CITY OF ONTARIO DEVELOPMENT ADVISORY BOARD

- B. ENVIRONMENTAL ASSESSMENT AND DEVELOPMENT PLAN REVIEW FOR FILE NO. PDEV18-033:** A Development Plan to construct an approximate 72,433-square foot automobile dealership (Porsche) on 3 acres of land located on the south side of Inland Empire Boulevard, 367 feet east of QVC Way, within the Urban Commercial land use district of the Meredith International Centre Specific Plan. The environmental impacts of this project were previously reviewed in conjunction with the Meredith International Centre Specific Plan Amendment (File No. PSPA14-003), for which an Environmental Impact Report (SCH No. 2014051020) was certified by the City Council on April 7, 2015. This application introduces no new significant environmental impacts, and all previously-adopted mitigation measures are a condition of project approval. The proposed project is located within the Airport Influence Area of Ontario International Airport, and was evaluated and found to be consistent with the policies and criteria of the Ontario International Airport Land Use Compatibility Plan (ALUCP). (APN: 0110-321-73) **submitted by Whitfield Associates, Inc.**

DESCRIPTION: A Development

Exhibit D—LANDSCAPE PLAN

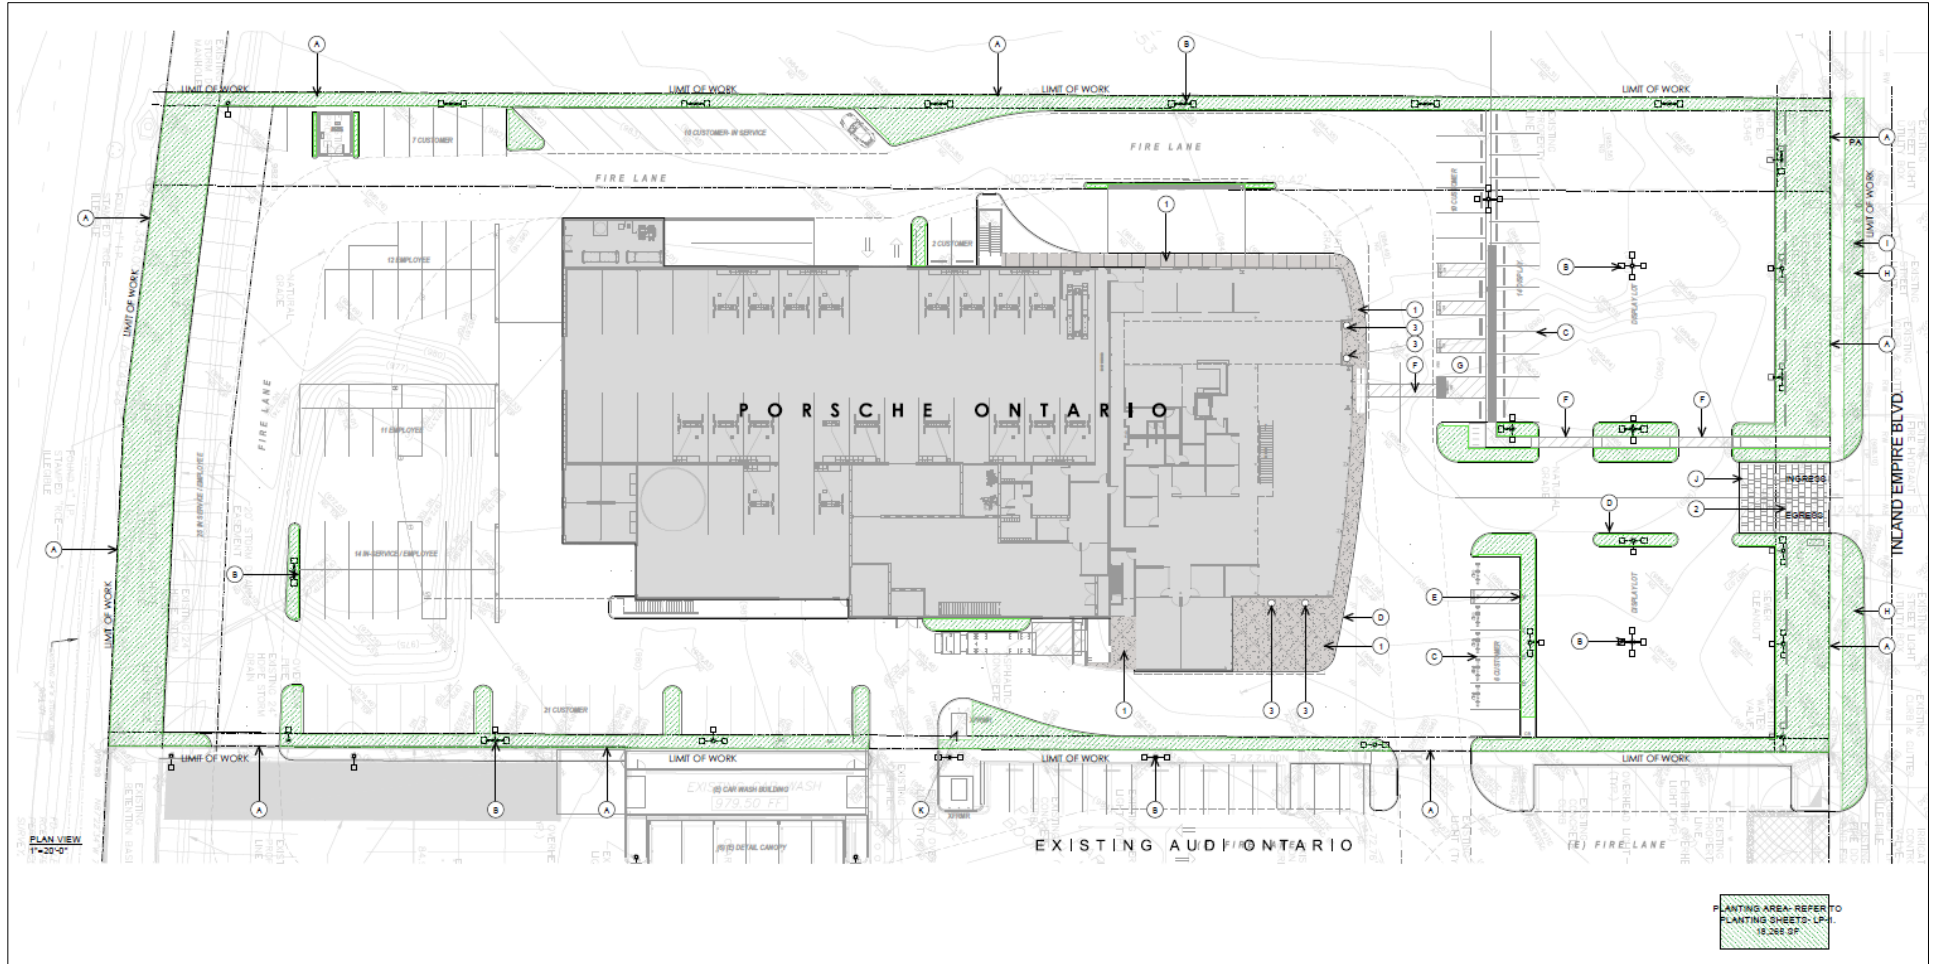
A Preliminary Landscape Plan (dated 10/29/18) meets the Standard Conditions for New Development and has been approved with the consideration that the following conditions below be met upon submittal of the landscape construction documents.
